FINDING OF NO SIGNIFICANT IMPACT FOR THE PROPOSED TRINIDAD RANCHERIA ECONOMIC DEVELOPMENT CORPORATION HOTEL PROJECT

ACTIONS Finding of No Significant Impact

EXHIBIT A

COMMENTS ON EA

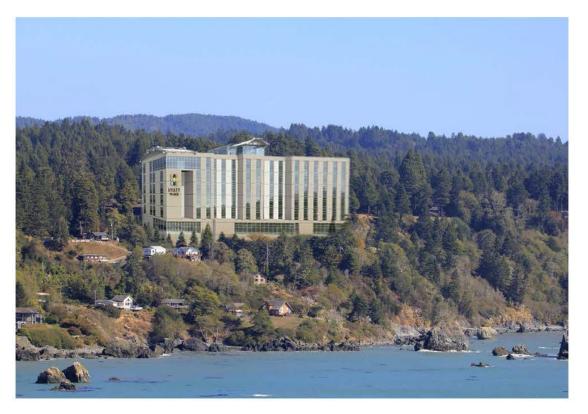
Perhaps the most obvious method to illustrate the incompatibility of a six-story structure with the natural coastal landscape is to superimpose such a structure on the panorama displayed in Figure 4. Figure 6 displays such a superimposition.

If one imagines being in a kayak in Trinidad Bay, paddling across from the existing casino complex, the view with six story hotel imposed would look like that in Figure 7. No words are needed to dramatize the incompatibility of the proposed 6 story structure with the natural landscape.
